STAFF RECOMMENDATION 807 Boscobel Street March 21, 2012

Application: New Construction – addition
District: Edgefield Historic Preservation Zoning Overlay
Council District: 06
Map and Parcel Number: 08216029700
Applicant: Chis Crimmins, Crimmins Construction LLC
Project Lead: Sean Alexander, sean.alexander@nashville.gov

Current Appearance

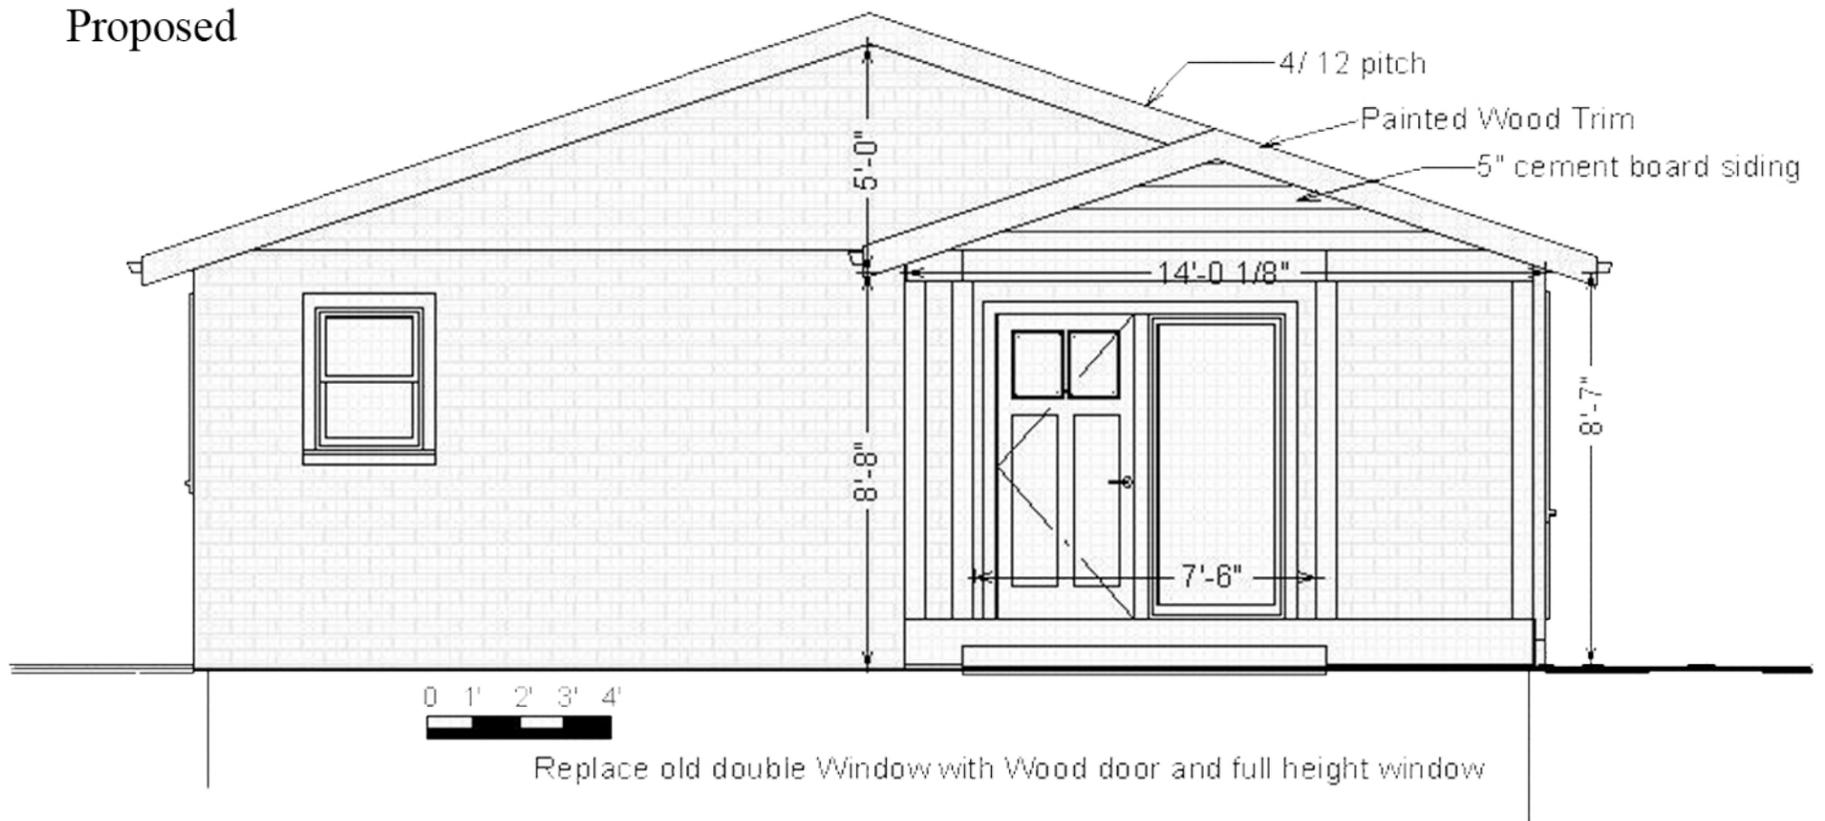
The stoop will have a fourteen foot (14') wide by four feet (4') deep footprint on the right half of the front of the building. The stoop will have a roof "nested" into the existing roof, matching the pitch but sitting three feet (3') lower than the existing roof peak. The eave height will match the existing eave line at approximately nine feet (9') above grade. The addition of a front entrance will make the structure more compatible with historic houses nearby, which all have front porches that address the street. Although the Commission has typically asked that front porch additions be at least six feet (6') deep, Staff finds that the smaller stoop is appropriate on a one-story structure with a low-pitched roof and to extend the depth more would create an inappropriate setback. Staff

Currently there are two windows on the front elevation and the entrance to the front unit, as it is with the other units, is on the right side of the building. The proposal would relocate the door from the side to the location of the existing right-front window. The door will be a wooden panel-door with glass panels at the top with one large side-light on the right. A window will replace the existing door on the right side. Staff finds the proposed window and door rhythm, though contemporary, to be appropriate with historic houses nearby because the proportion and rhythm will be more compatible than is currently found on the non-contributing structure. This meets guideline III.B.2.f.

The front stoop will have a concrete floor, wooden columns, and cement-fiber siding in the gable. The new roof will be asphalt shingle, matching the texture of the existing roof. The color of the roof will need to be approved by staff prior to permitting. The new front door will be wood, and the windows will be composite sashes in the existing wooden frames. Staff finds these materials to be compatible with historic houses and to meet guideline III.B.2.g.

Staff recommends approval of the proposed front stoop addition and door relocation, with the condition that that the roof and paint colors be appropriate, as approved by staff, finding the proposal to meet the Edgefield Historic Preservation Zoning Overlay design guidelines.

Current Appearance

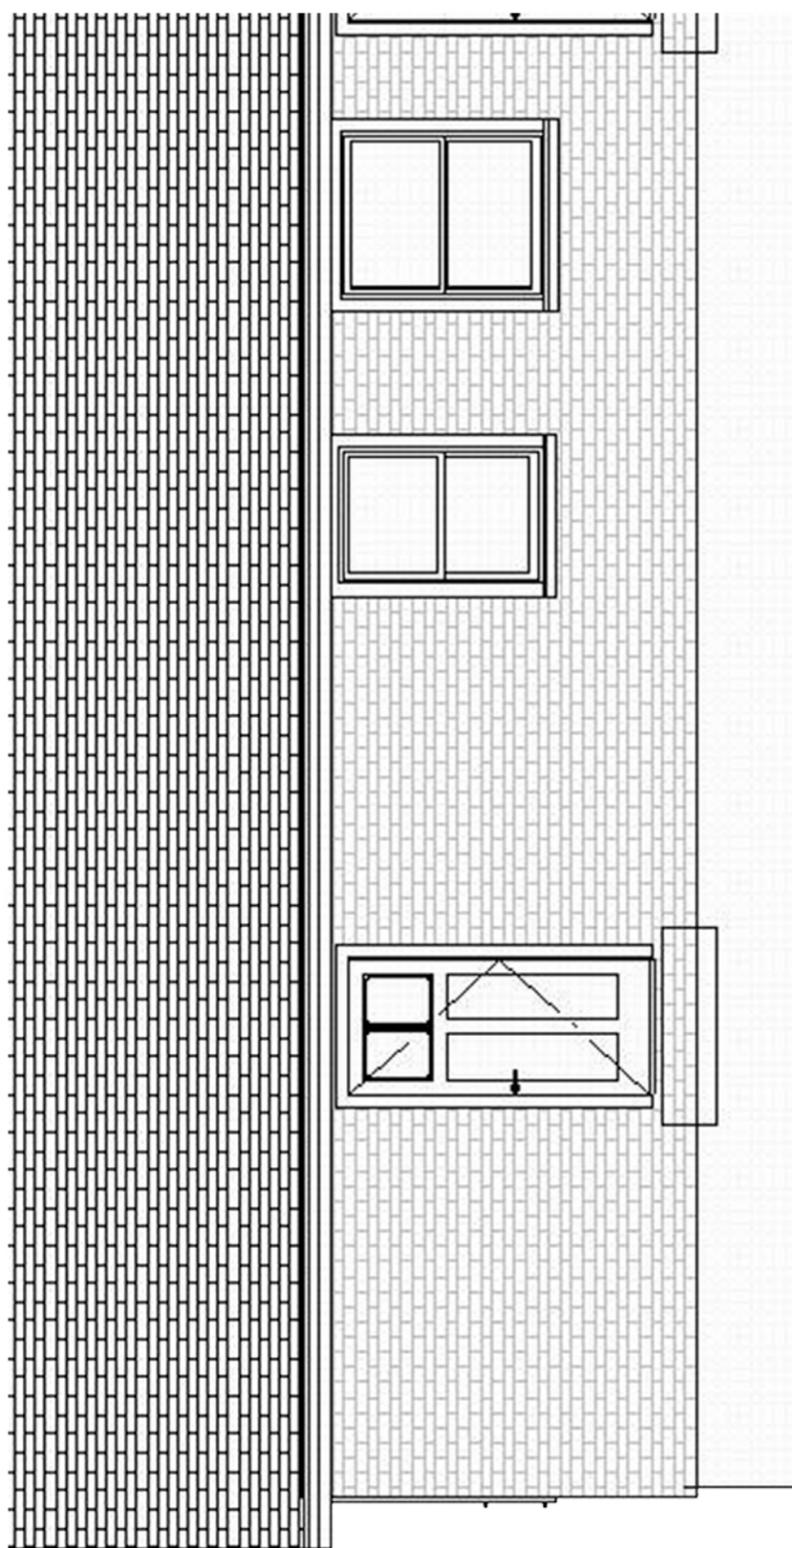
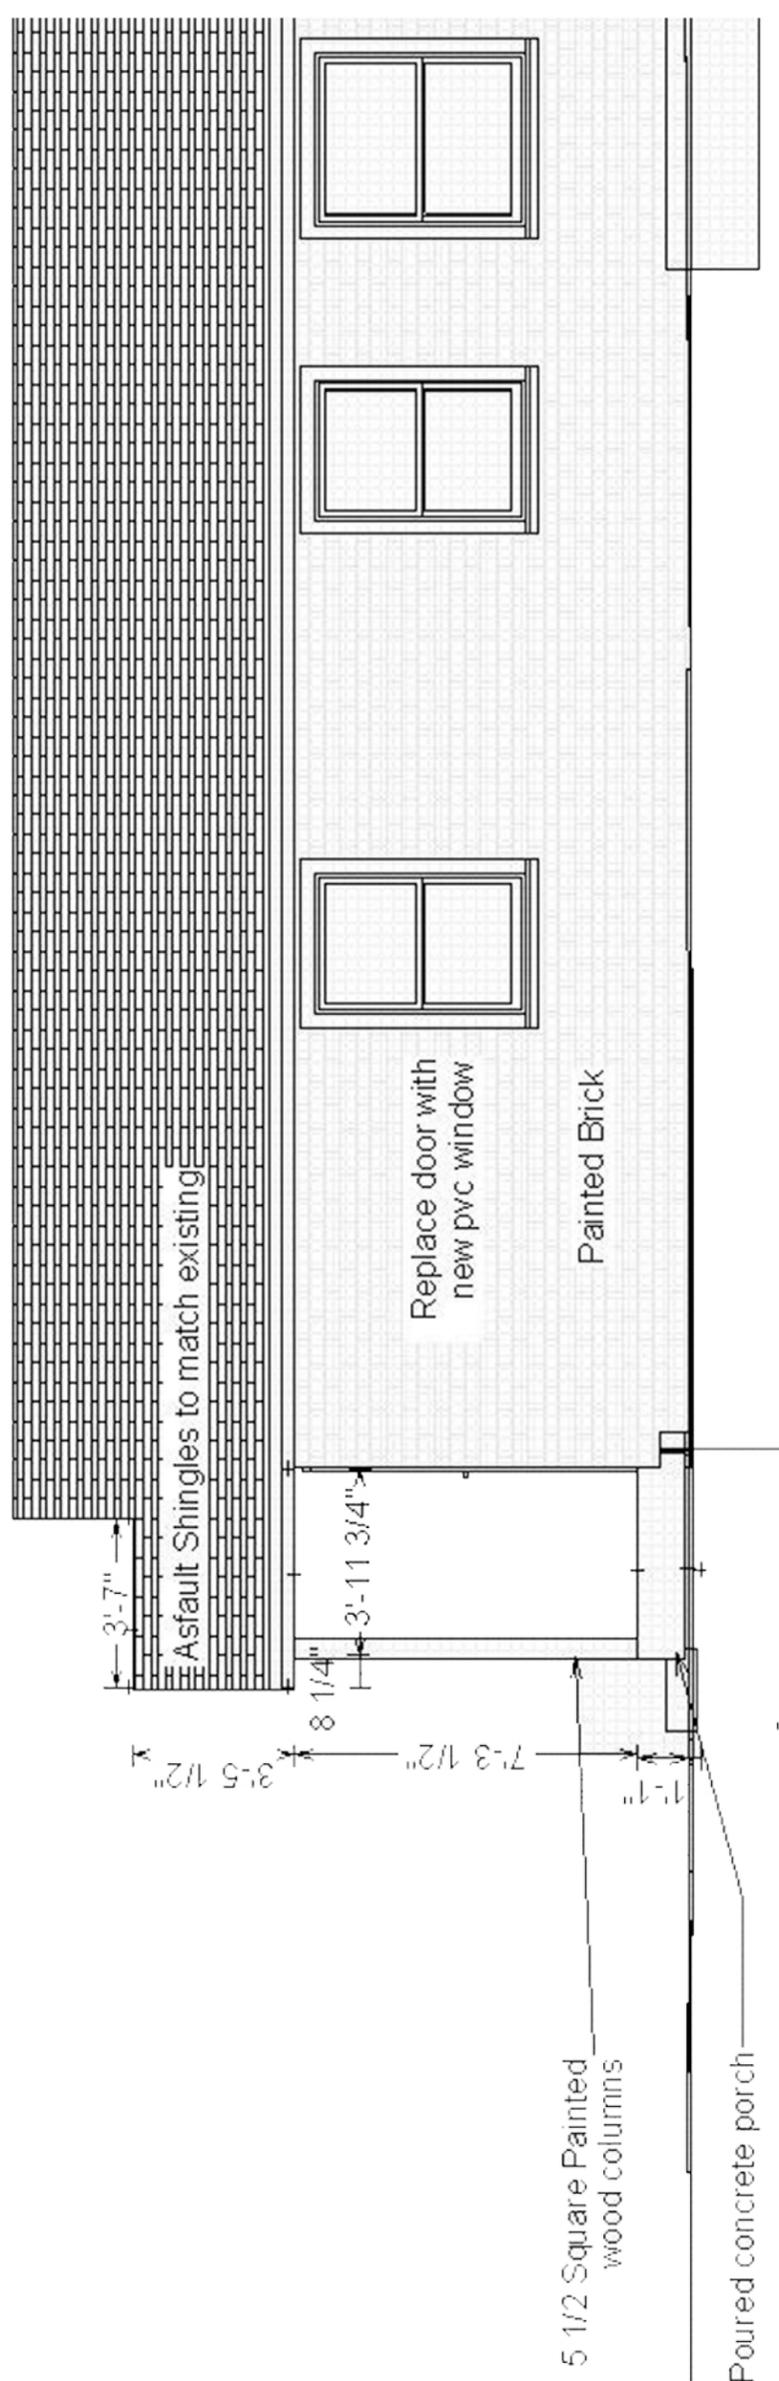
Additionally, the relocation of the door and window will result in sections of mismatched masonry and mortar, which will be painted to achieve a uniform appearance. Staff will need to review and approve the paint color prior to permitting.
